PROCEDURE 1092.193 - ADMINISTRATIVE CONTROL
OF INSERVICE INSPECTION (ISI) CALIBRATION STANDARDS

ATTACHMENT 5

FIRST 10-YEAR INTERVAL RELIEF REQUESTS

RELIEF REQUEST 1991-1

Figure
4.2-13

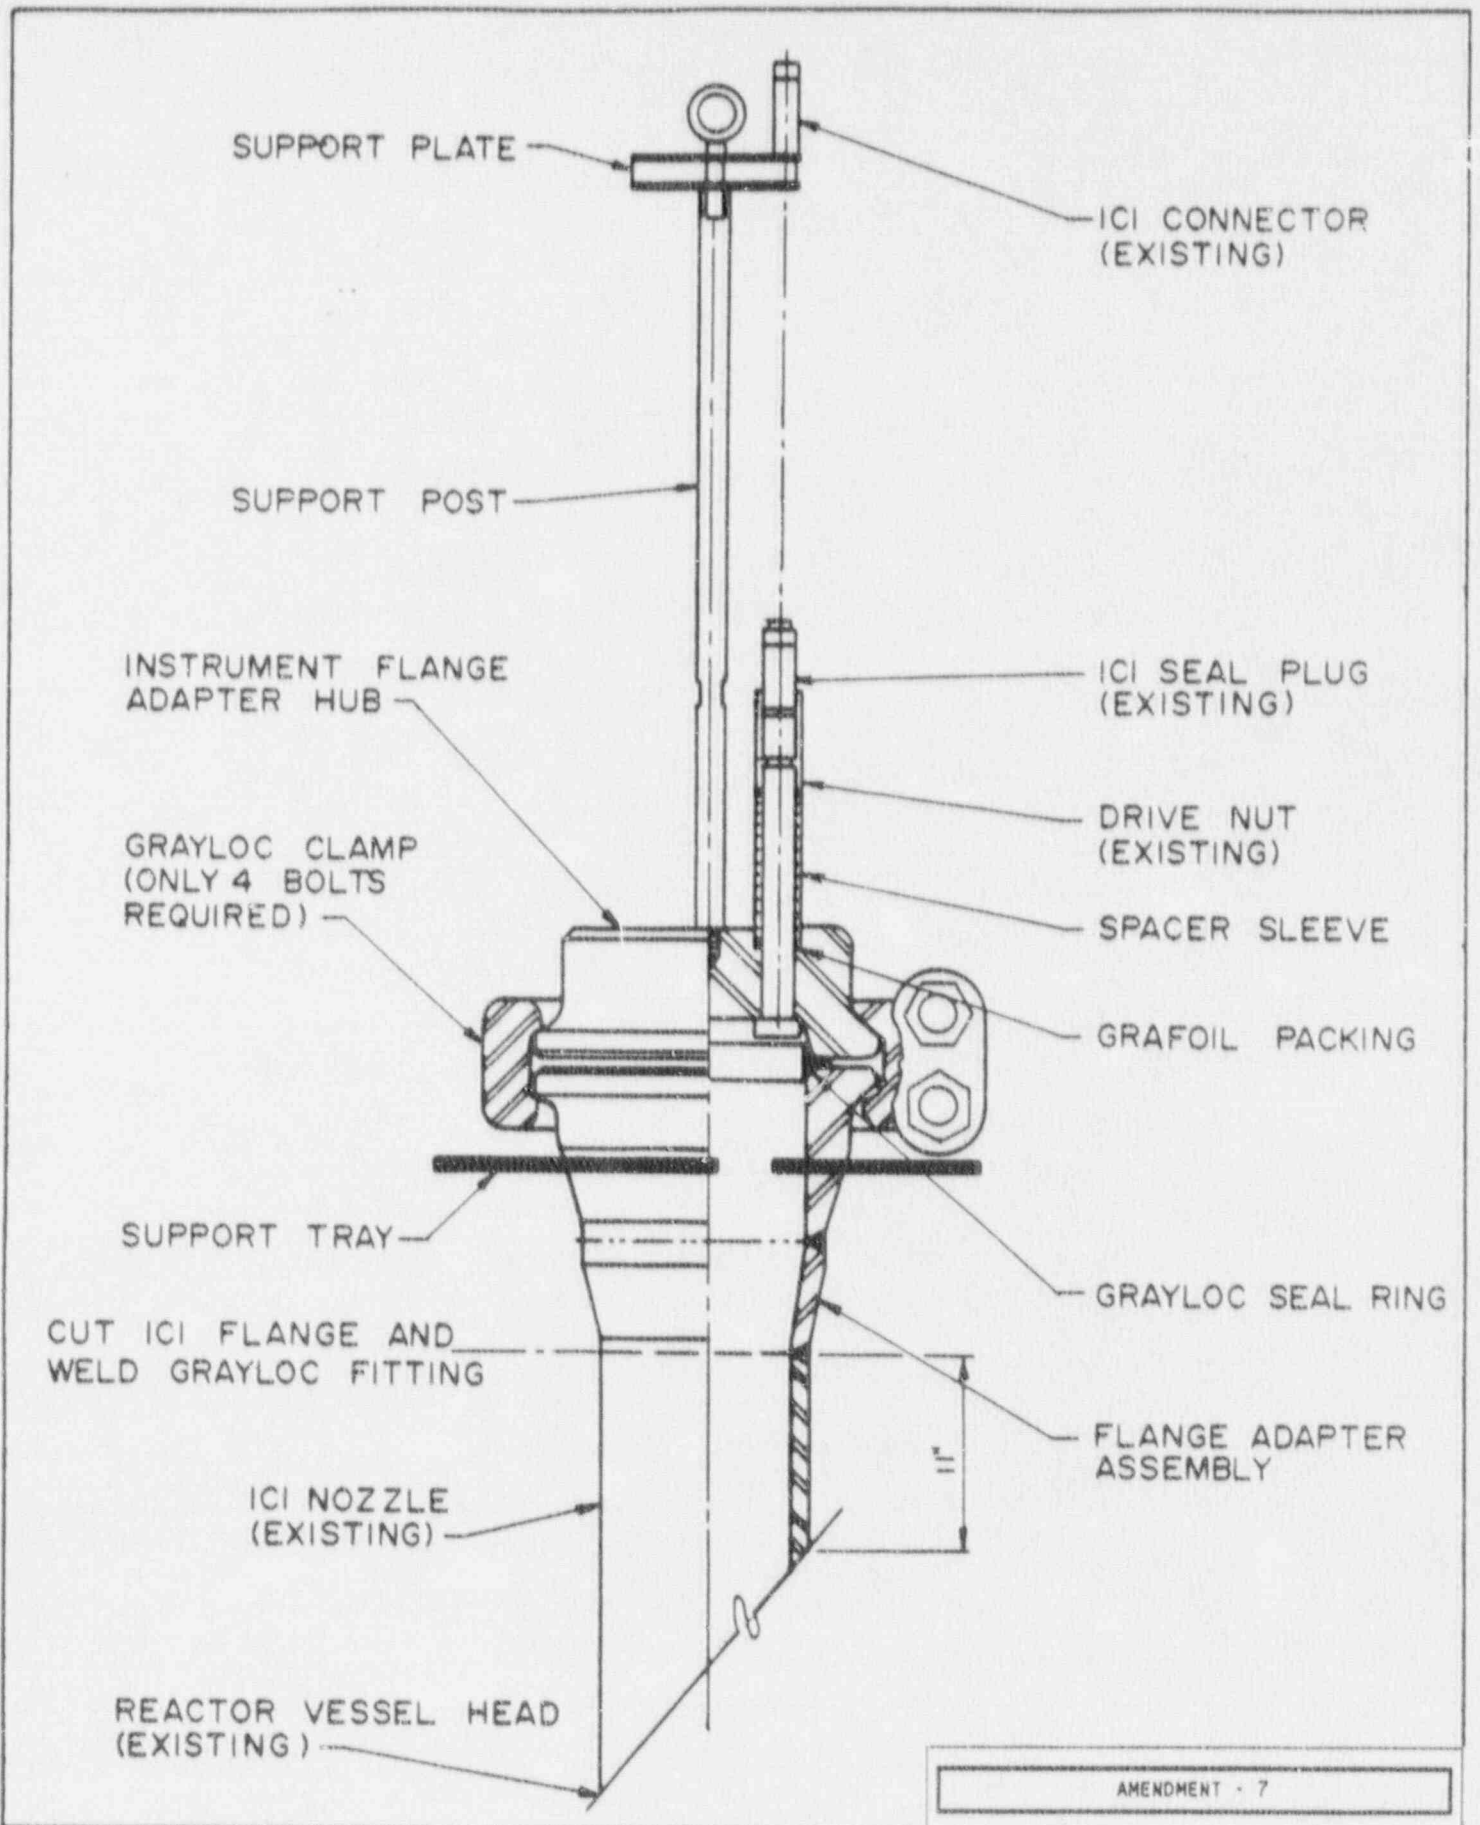
Bolting for the Eight (8) Incore Instrumentation (ICI) Flanges on the Reactor Vessel Closure Head. (See Figures 4.2-13 and 4.2-14)

All pressure-retaining bolting (bolts, studs, nuts) shall receive a visual (VT) examination. Later editions and addenda of Section XI further clarify the requirement by specifying a VT-1 examination which is conducted to determine the condition of the component including such conditions as cracks, wear, corrosion, erosion, or physical damage.

Impractical code requirement due to limitation of design. During the first 10-year interval of commercial operation (March 26, 1980, to March 26, 1990), the ICI bolting was inaccessible due to the design of the reactor vessel shroud that covers the reactor vessel closure head.

A visual (VT-2) examination for leakage was performed on this general area of the reactor vessel closure head during each system leakage test or hydrostatic test following each reactor refueling outage. In addition, the original design of these

flanged joints was replaced with a different design in May 1988. Presently, plans have been developed to modify the design of the reactor vessel shroud to allow for greater access to items enclosed by the shroud, including these ICI flanges. This bolting should be more accessible during the second 10-year interval and will be examined to the extent practical, up to and including a full Section XI examination, if possible. The VT-2 examination for leakage will continue as in the past.

Fig. 8 Closure Head Assembly
Revision 2, August 1978
Contract 7317b

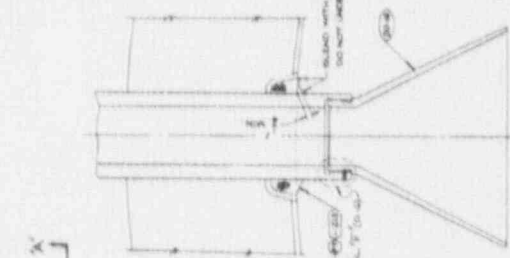
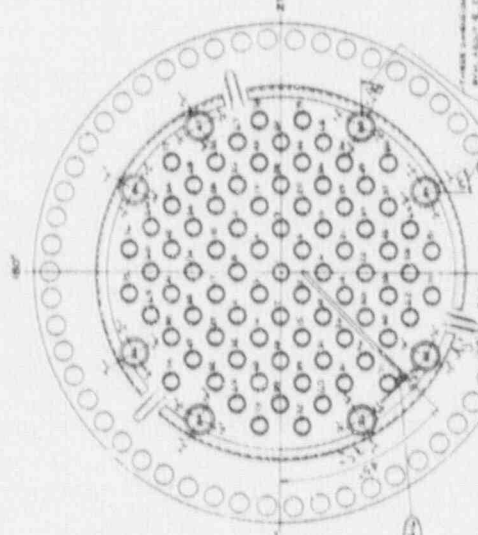
All four welds in each of three peripheral Control Element Drive Mechanisms (CEDMs) on the Reactor Vessel Head. (See Figure 8, "Closure Head Assembly")

Volumetric examination of 100% of the welds in 10% of the 28 peripheral control rod drive housings.

Impractical code exam due to limitations of access due to design. The CEDMs are inaccessible due to the design of the Reactor Vessel Shroud that covers the Reactor Vessel Closure Head.

A visual (VT-2) examination for leakage was performed on this general area of the Reactor Vessel Closure Head during each system leakage test or hydrostatic test following each reactor refueling outage. Presently,

plans have been developed to modify the design of the Reactor Vessel Shroud to allow for greater access to items enclosed by the shroud including these CEDMs. During the second 10-year interval, these three CEDMs should be more accessible and will be examined to the extent practical up to, and including, a full Section XI examination. The VT-2 examination for leakage will also continue as in the past.

Shear Key Detail (Total - 3)

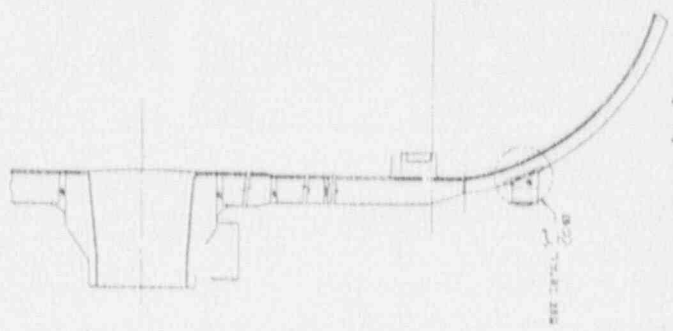
Reactor Vessel Shear Keys. Three lugs on the lower head of the Reactor Vessel. (See Figure E234-097, Figure 5.5-12, and Figure 1)

Impractical code requirement due to design and access limitations. The Reactor Vessel Shear Keys are inaccessible from the ultrasonic examination performed from the vessel interior due to the location and fabrication details. The shear key welds would be internally inaccessible due to the core stop lugs and flow baffle in the bottom of the vessel (See Figure 1). An examination from the exterior of the vessel is impractical due to restricted access from the three support columns. Additionally, the dose rate in the area of the shear keys is approximately 3 Rem per hour. While this would not absolutely prohibit access, it is high enough to be an ALARA concern due to the time to perform the exams (estimated at 1 hour each). Access is restricted in this area except in extreme cases.

When the reactor vessel was constructed, these shear keys were inspected to the requirements of ASME Section III which required a magnetic particle examination. Later, during the Preservice Inspection of Section XI, they were inspected to the extent practical from the exterior of the vessel using ultrasonics. During the first inspection interval, they were inaccessible. During the upcoming second interval, they will be exempted from inspection per ASME Section XI, 1986 Edition, with no addenda. There appears to be no safety issue in not performing an exam. No seismic event has occurred which would have put a shear load on these supports. Therefore, no alternative testing for the first inspection interval is proposed.

Figure
 5.5-12

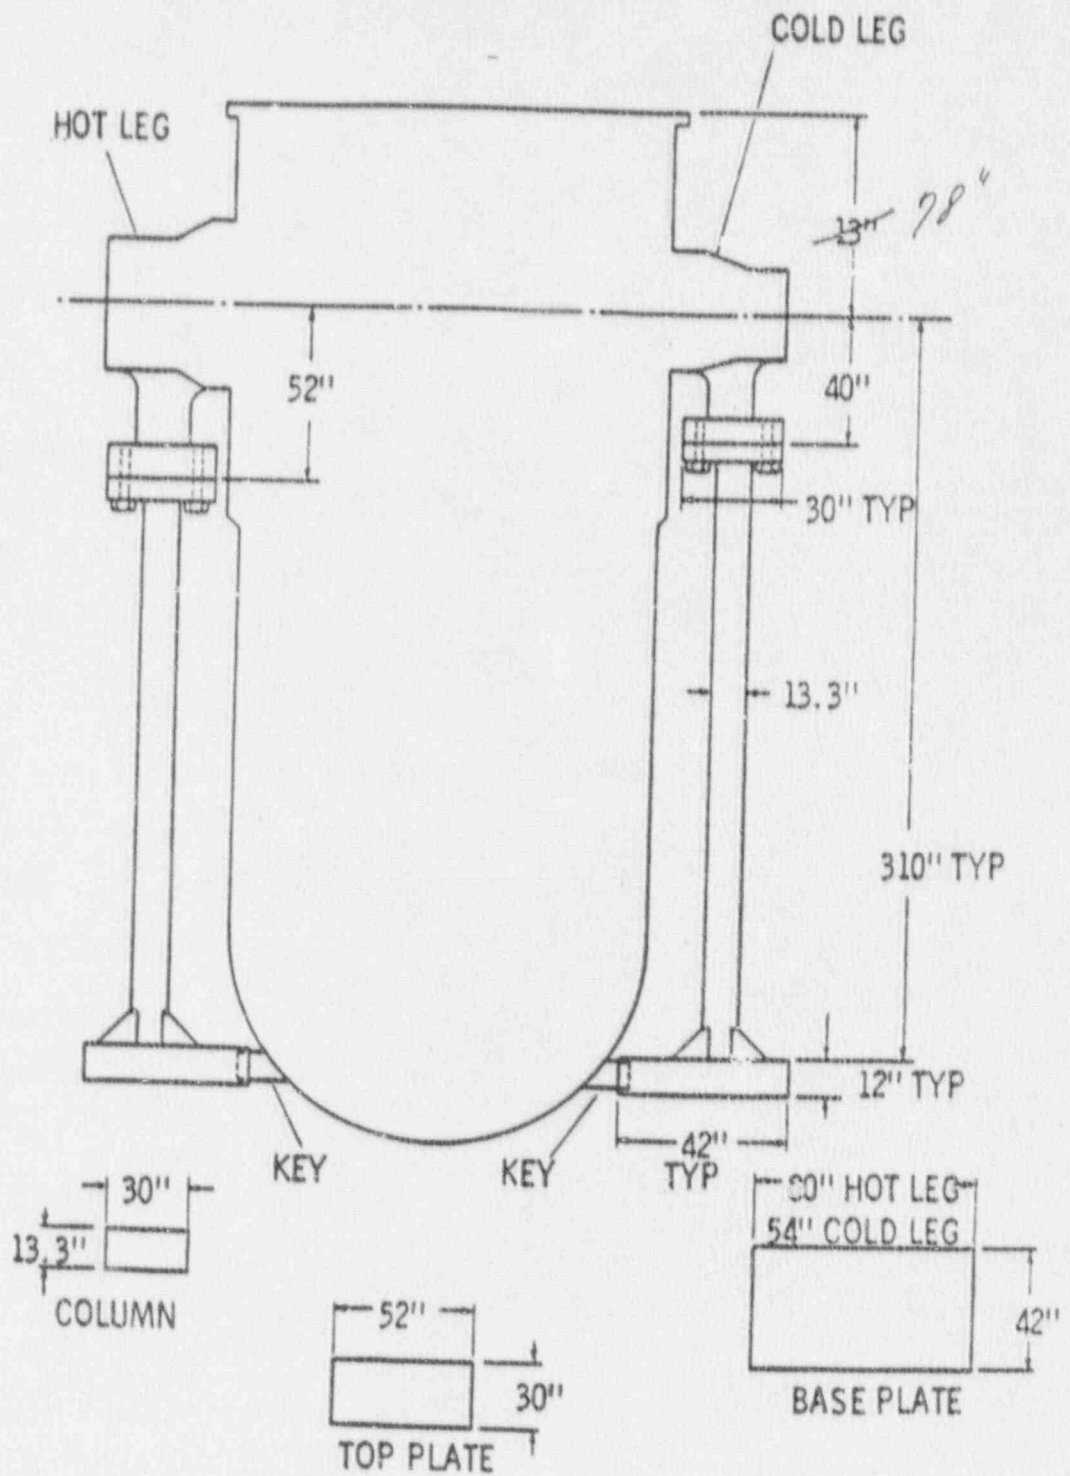
Volumetric examination of 100% of all integral vessel supports.

The shear keys are under no operating load and do not carry any weight. They would act as lateral stops, or bumpers, for the support columns during a seismic event. Under later editions of Section XI, these shear keys would be exempted from examination since they do not perform a component support function.
